907 NW MARKET ST

RECOMMENDATION MEETING
NORTHWEST BOARD | 02/07/2022
3036107-LU

EARLY DESIGN GUIDANCE RESPONSES |
MASSING OPTIONS & DESIGN CONCEPT

REQUESTED DEPARTURE #3

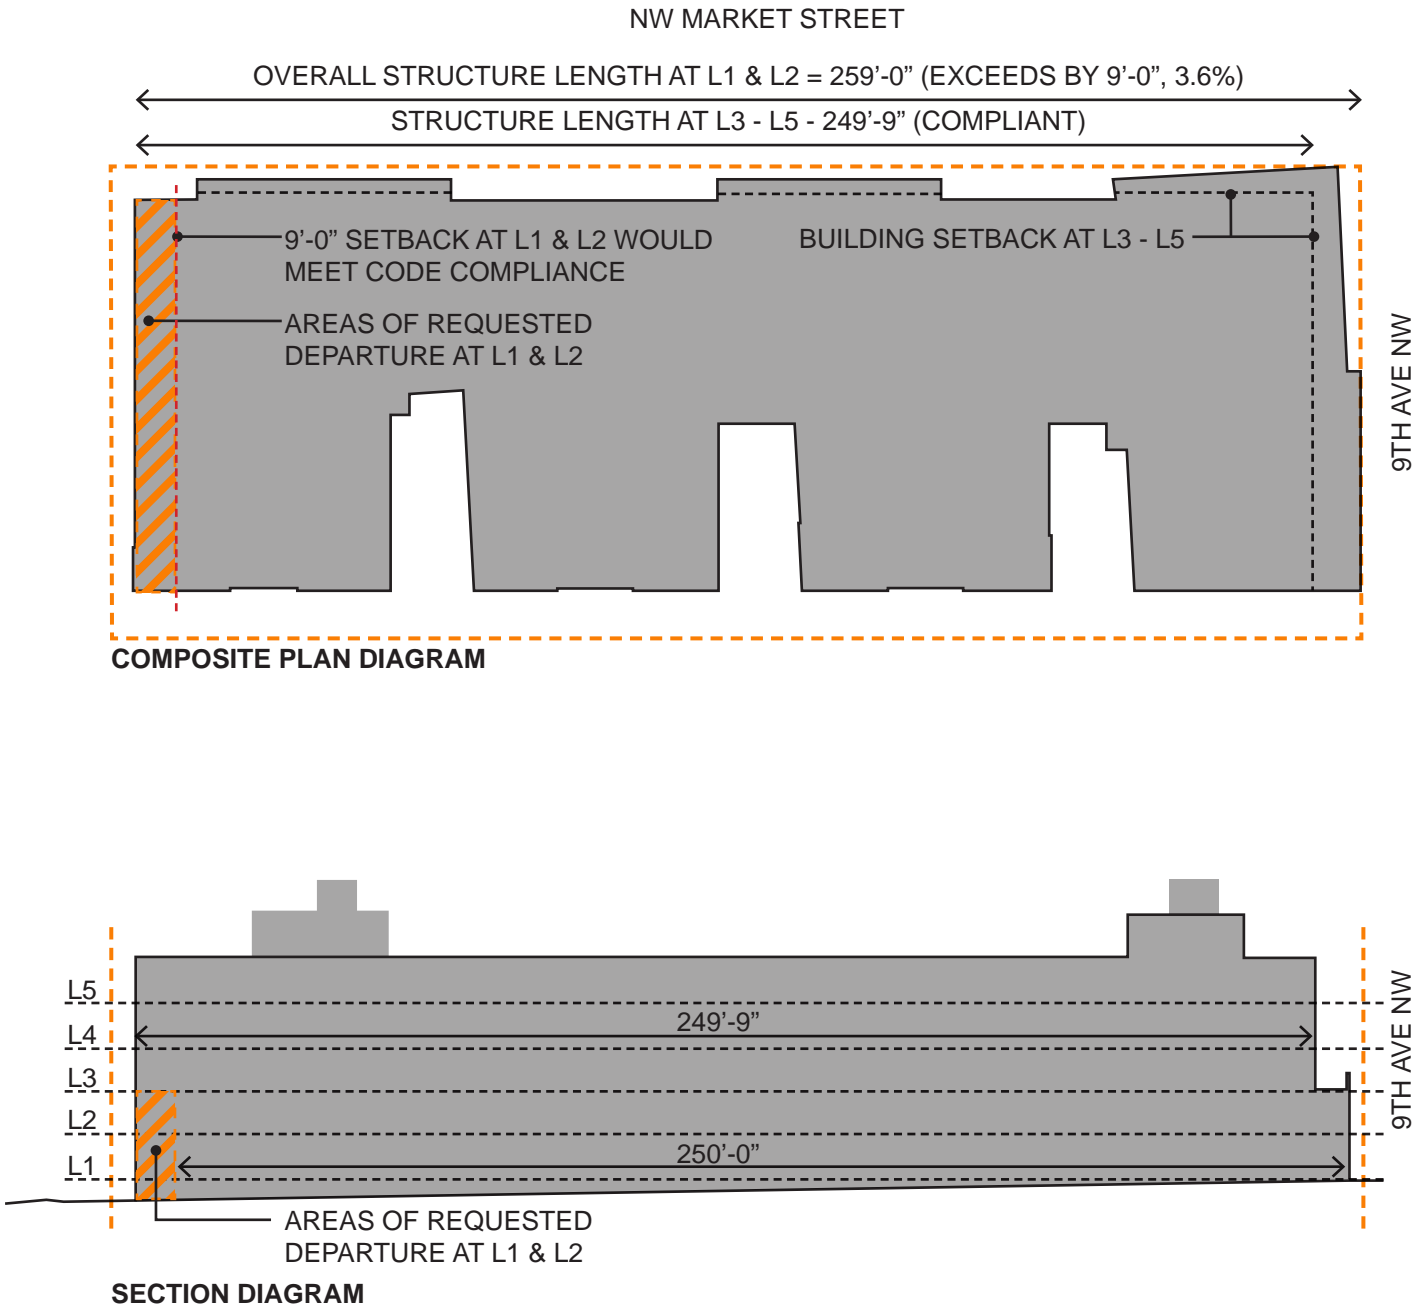
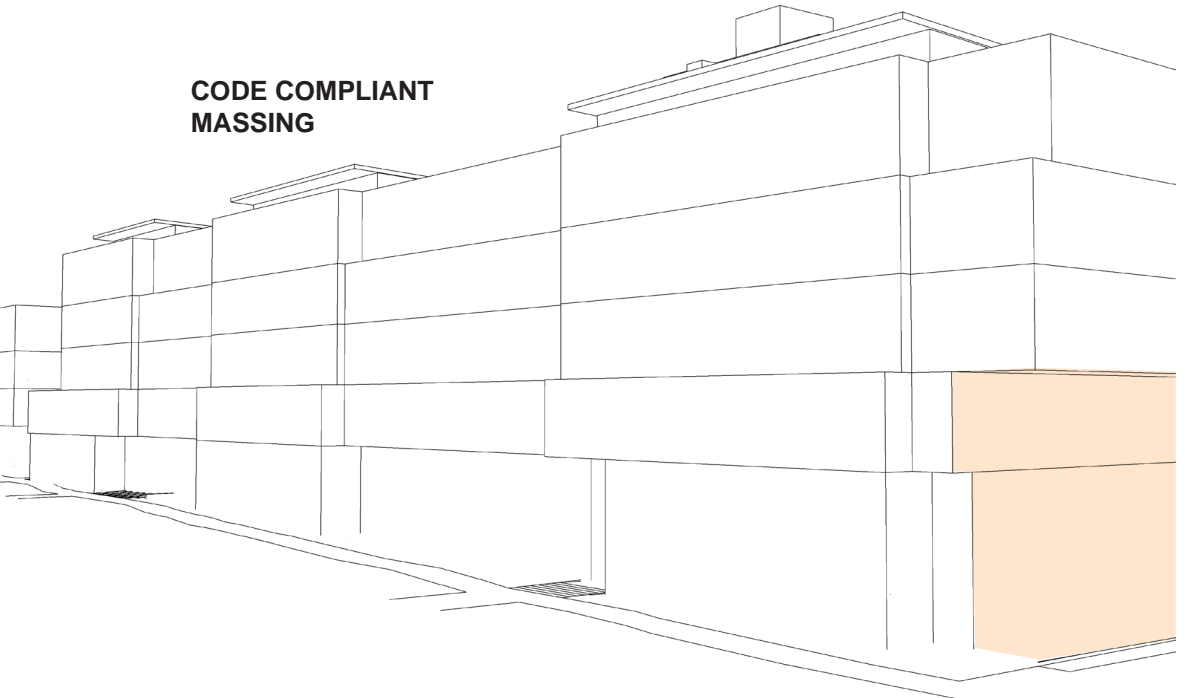
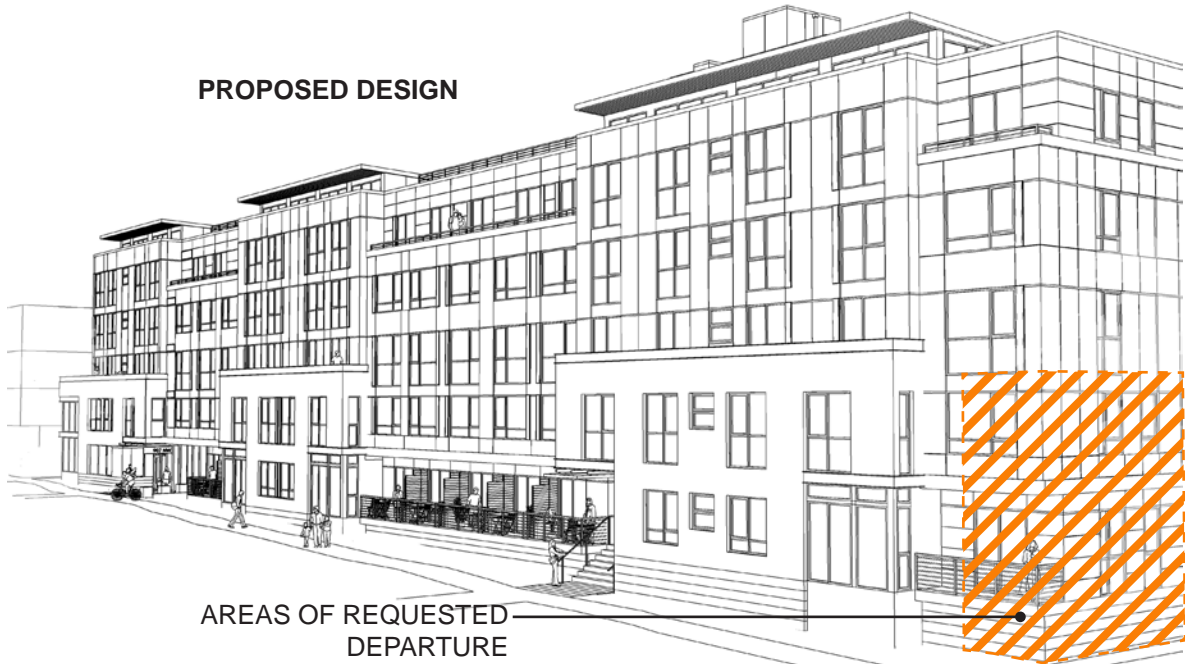
The structure at levels 1 and 2 is 259'-0" wide, exceeding the 250'-0" maximum. At levels 3-5 the width is compliant at 249'-9".

A departure is requested for the level 1 & 2 structure width which exceeds the code prescribed maximum by 9 feet (less than 1%)

- The first two stories seek relief from the structure width maximum due to engagement of the street corner and pedestrian realm at the east edge. (CS2.A2, CS2.B2, CS2.C1, PL3.B4, DC1.A1)
- The setbacks and modulation at the upper levels meet the intent of the design guidelines by mitigating the bulk, scale, and long facade length of the structure while still allowing for engagement of the pedestrian realm at street level. (CS2.C3, DC2.A2)

REQUESTED DEPARTURE #4

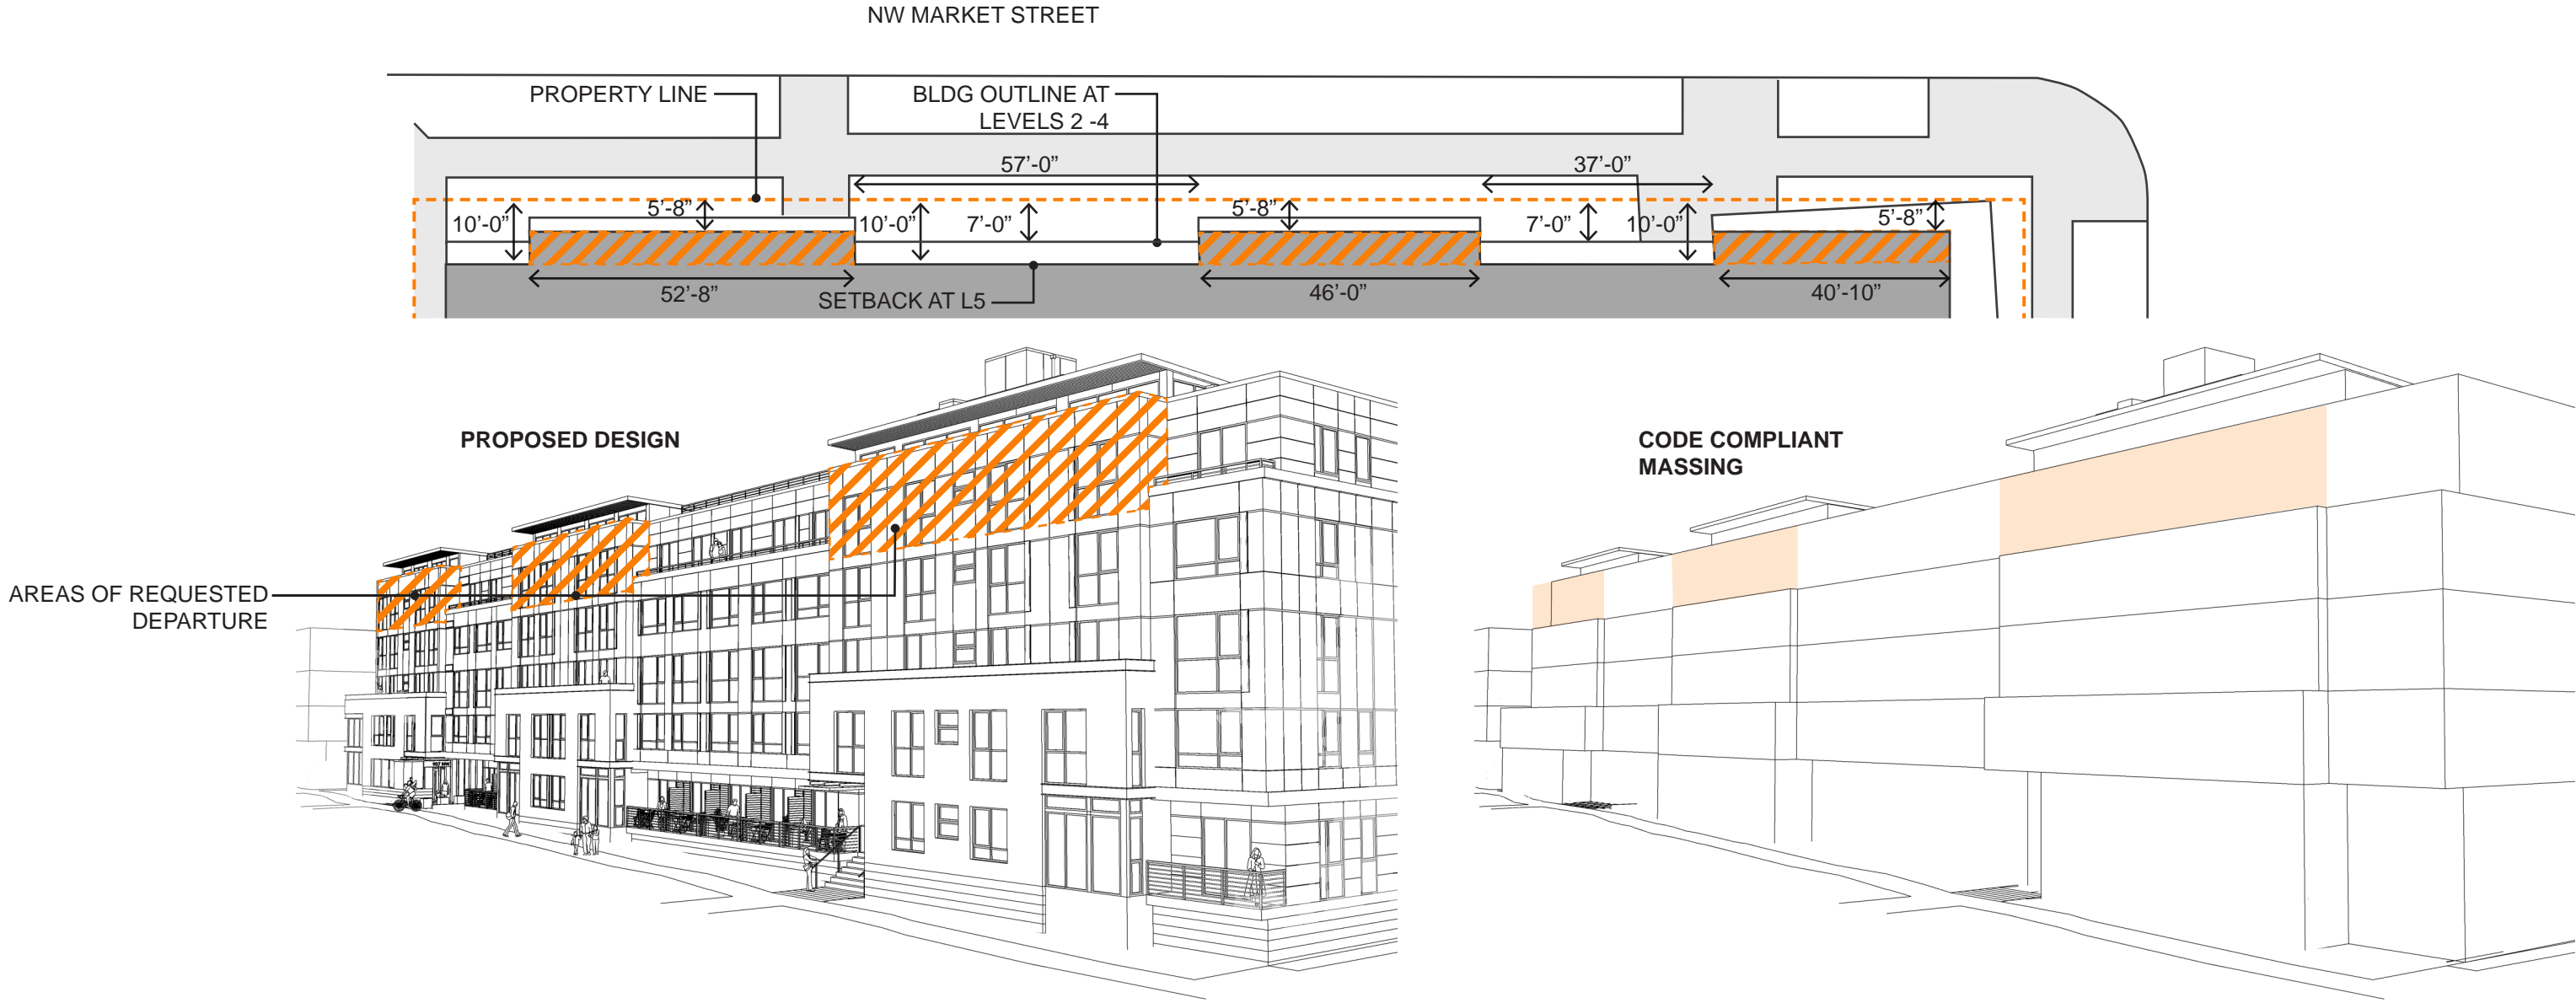
The facade is modulated and upper level setbacks are provided on levels 3-5, though they are only required at level 5. The setback distances that meet or exceed the minimum 10 foot dimension across most of the north facade, though there are three areas with a minimum distance of 5'-8".

A departure is requested at L5 for three projecting sections of the North facade with a proposed setback of 5'-8" (less than the code required 10'-0" minimum).

- Proposed modulation at upper story mitigates the overall length of the facade more than single, code-compliant unified setback and is consistent with the modulation at the lower levels and pedestrian realm. (CS2.C, CS2.C3, DC2.A2)
- Similar scale projects along Market(AVA & Koi apartments) do not provide upper level setbacks or significant modulation, instead favoring a simple, unified massing approach. (CS2.A1, CS3.A2)
- The proposed setbacks and modulation maintain the legibility of the board-preferred design parti. (CS2.C, DC2.A2)
- The robust landscape buffer from the back of walk to the structure edge further mitigates the structure's height, bulk, and scale. (CS2.D4, DC2.A2)
